MILANO

PLANNED UNIT DEVELOPMENT (PUD)
BINDING MASTER PLAN AMENDMENT

June 23 ~~April 4~~ November 16, 20223

PROJECT NARRATIVE

TITLE: **MASTER SITE PLAN**

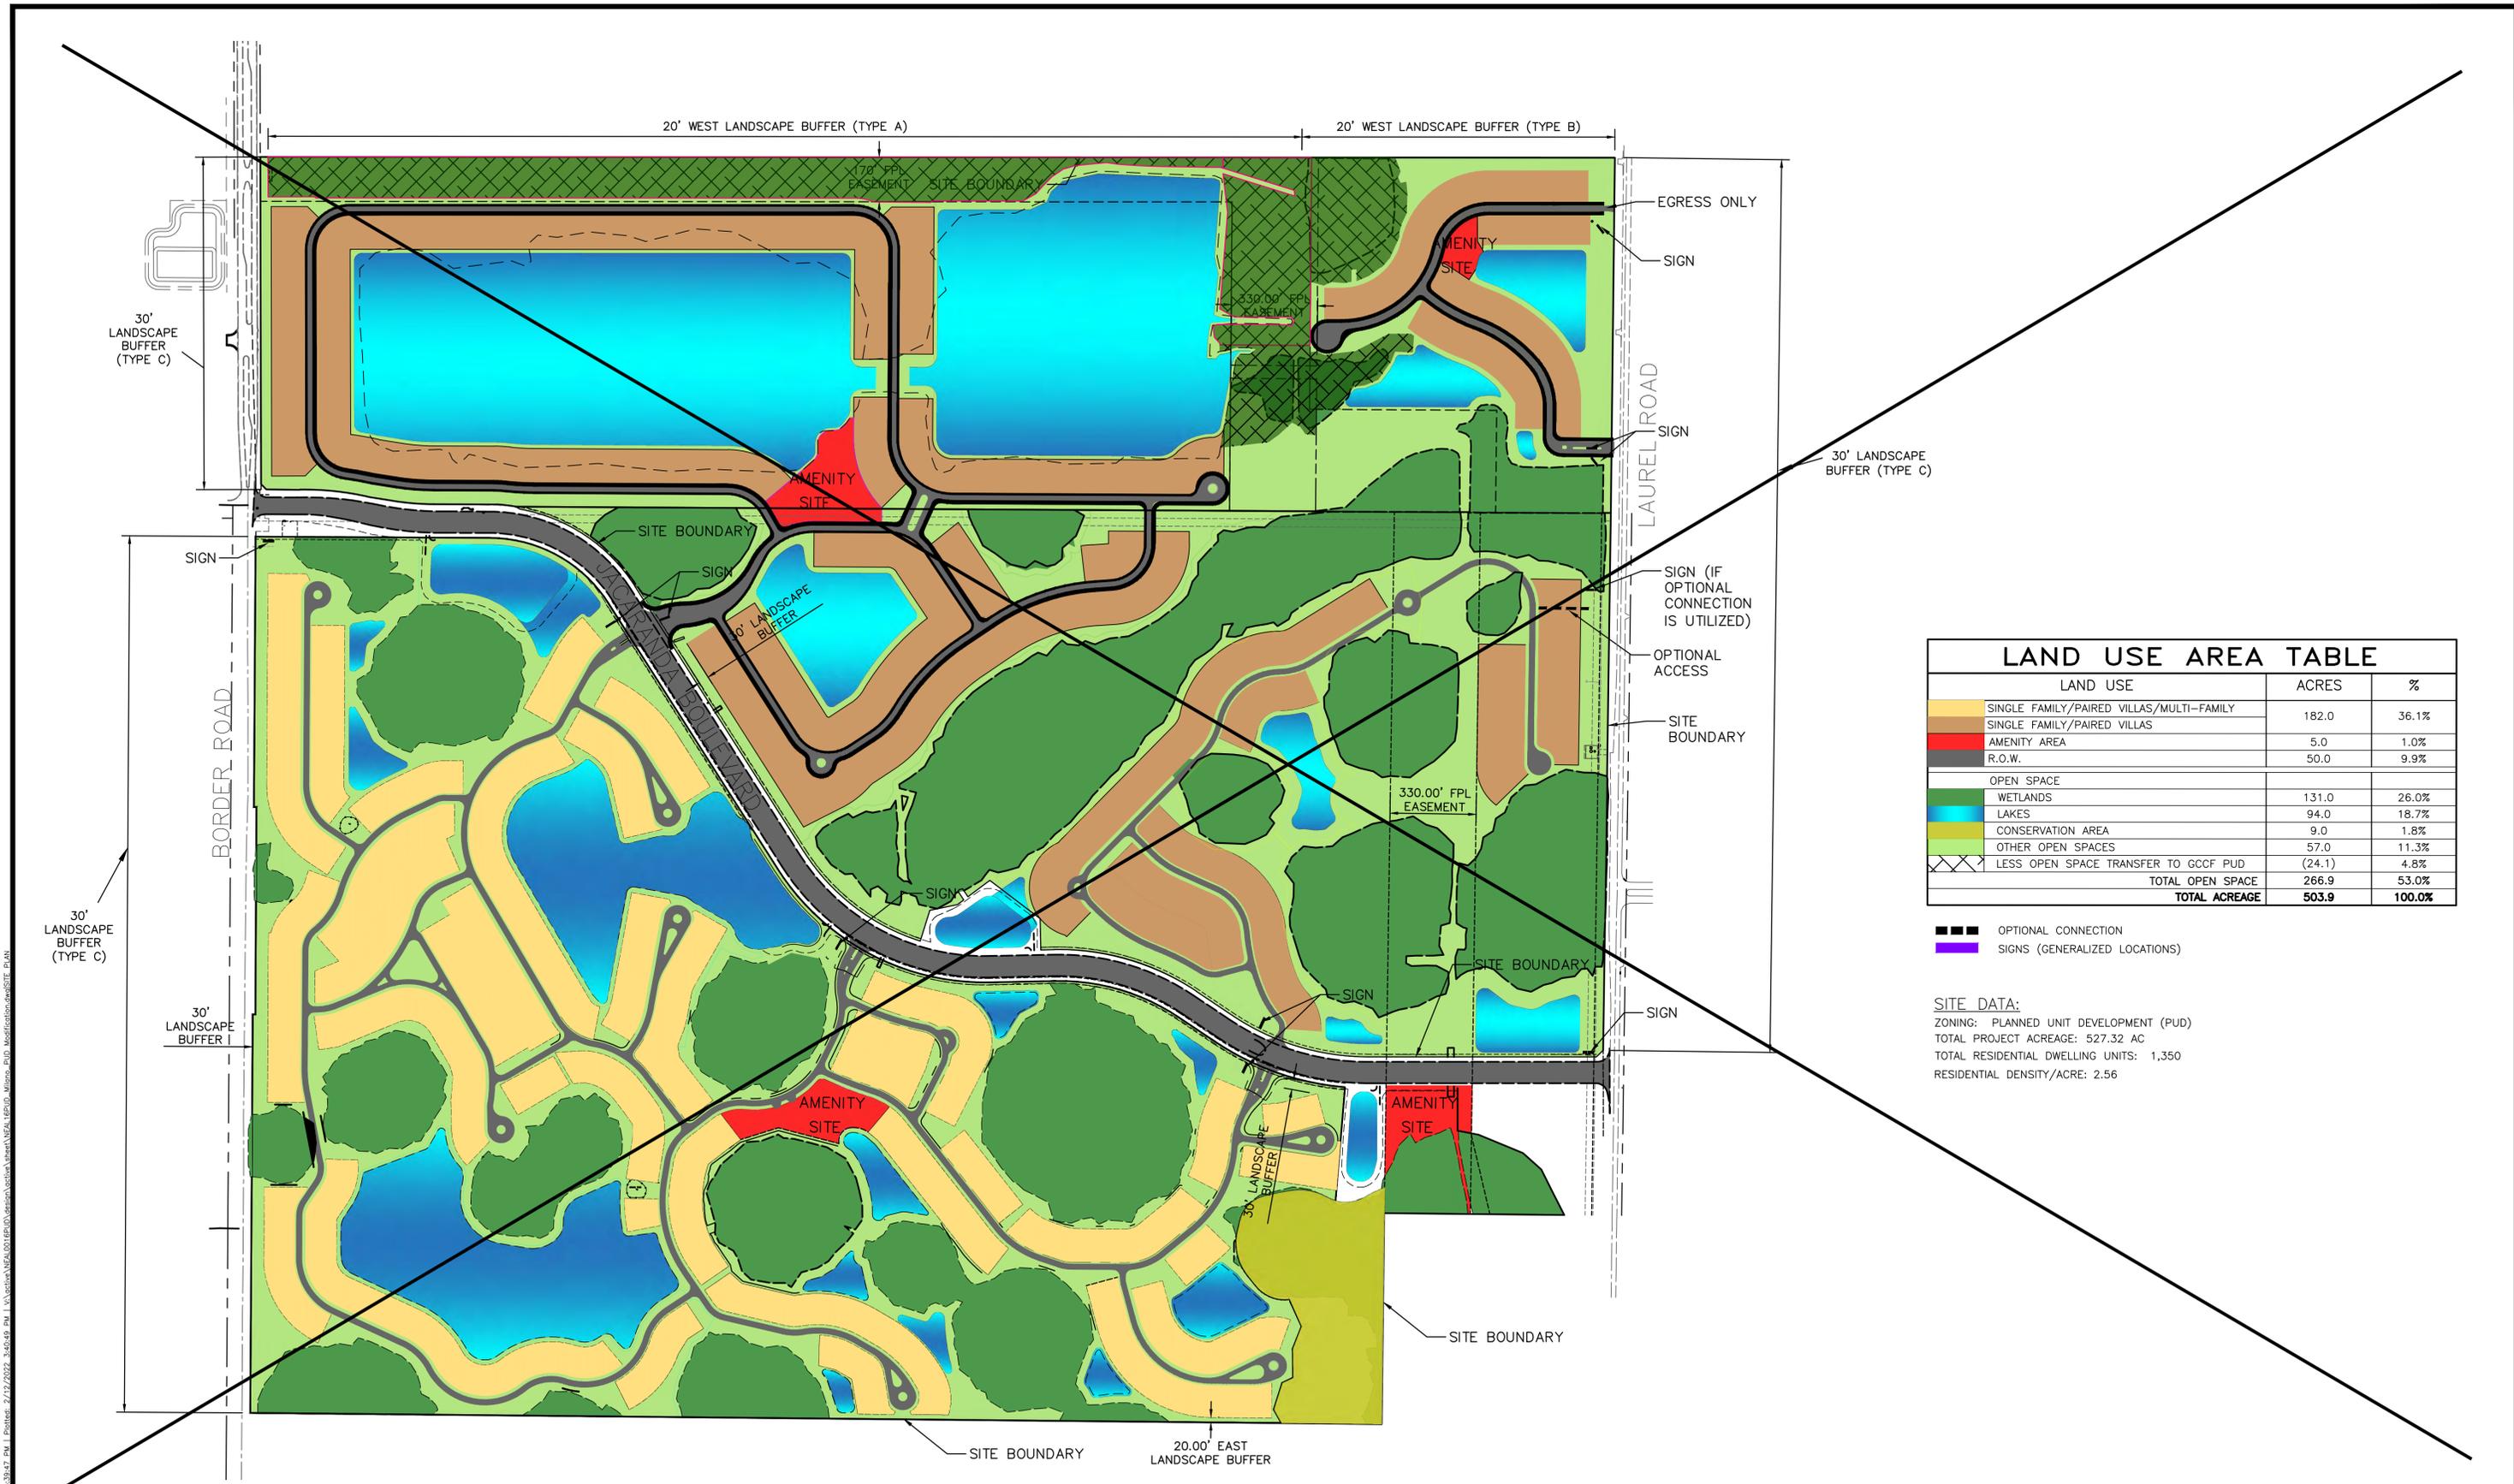
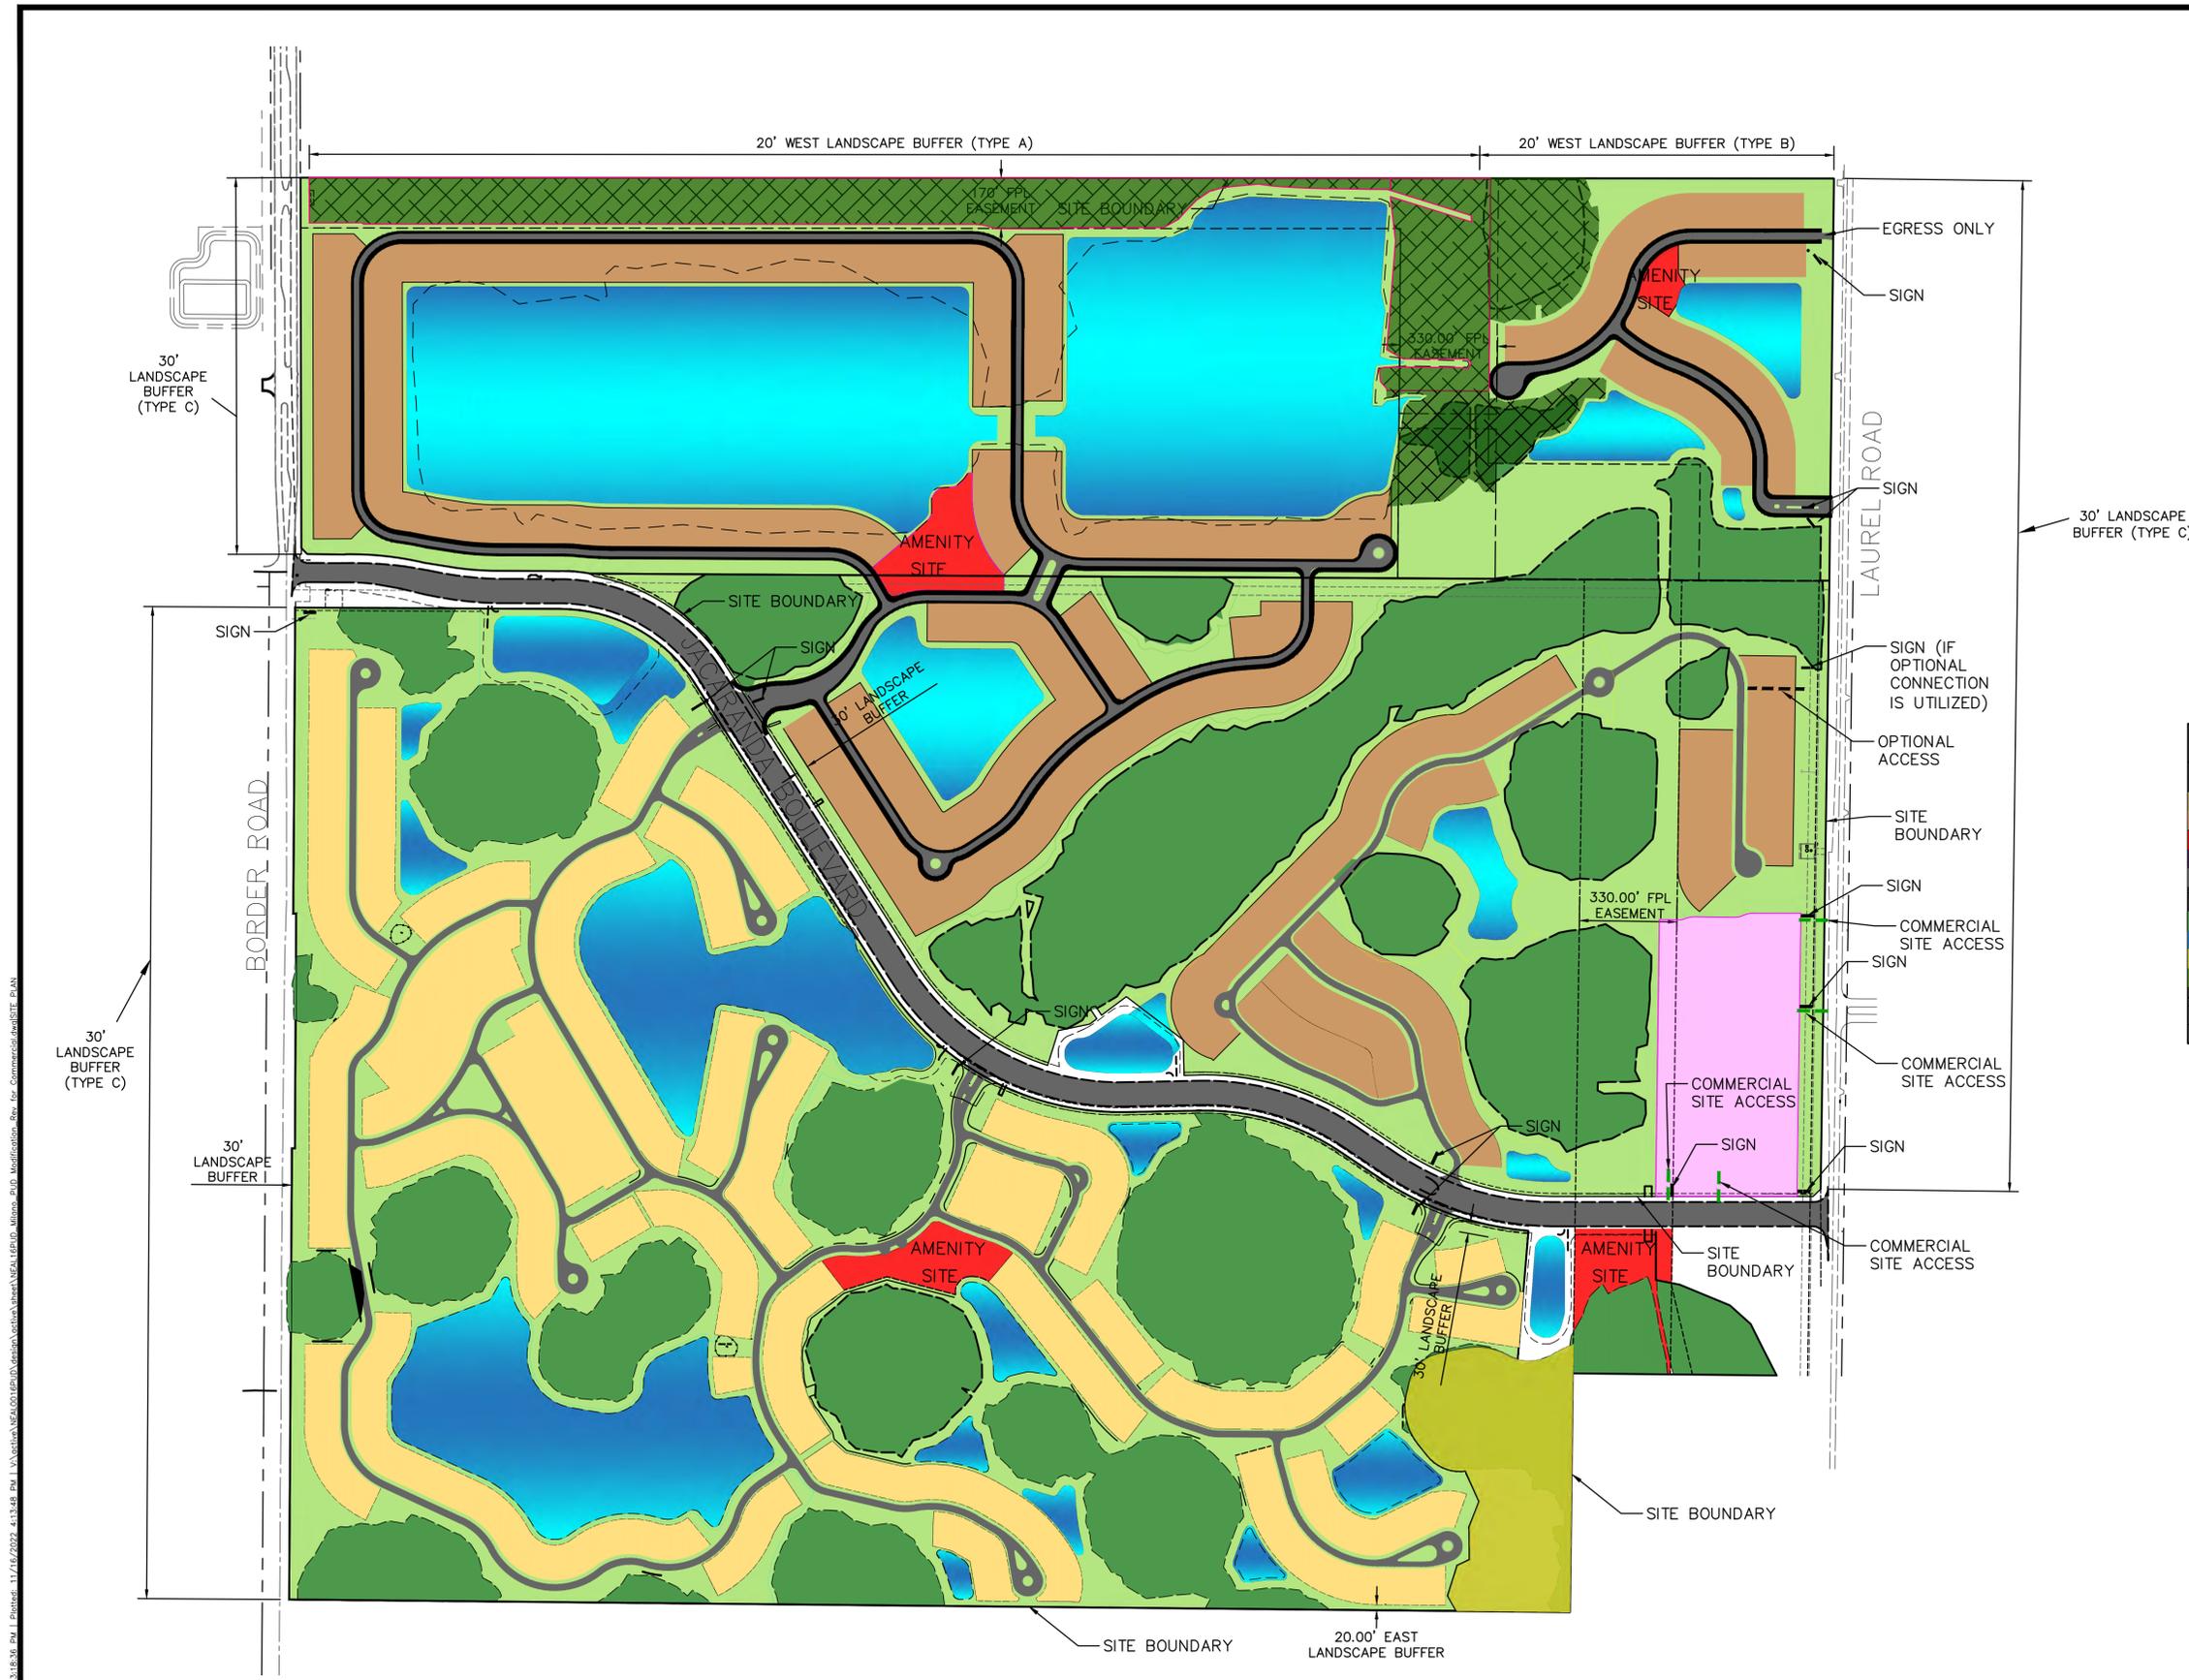
This amendment to the Milano PUD proposes to re-designate a 10.42 acre parcel at the southwest corner of the Jacaranda Boulevard and Laurel Road, within the Milano PUD, from Open Space to Commercial, to add access points for the Commercial parcel and establish development standards for the Commercial parcel. The proposed Commercial designated parcel will allow for the provision of limited retail and service uses to meet the needs of the residents of the PUD while reducing trip lengths and increasing multi-modal accessibility to such services for the residents. The PUD requirement for a minimum of 50% Open Space will continue to be maintained.

2) Commercial- ~~None~~ Maximum 10.42 acres

LAND USE AREA TABLE		
LAND USE	ACRES	%
SINGLE FAMILY/PAIRED VILLAS/MULTI-FAMILY	182.0	36.1%
SINGLE FAMILY/PAIRED VILLAS		
AMENITY AREA	5.0	1.0%
COMMERCIAL SITE	10.4	2.1%
R.O.W.	50.0	9.9%
OPEN SPACE		
WETLANDS	122.2	24.2%
LAKES	92.2	18.3%
CONSERVATION AREA	9.0	1.8%
OTHER OPEN SPACES	57.2	11.4%
LESS OPEN SPACE TRANSFER TO GCCF PUD	(24.1)	4.8%
TOTAL OPEN SPACE	256.5	50.9%
TOTAL ACREAGE	503.9	100.0%
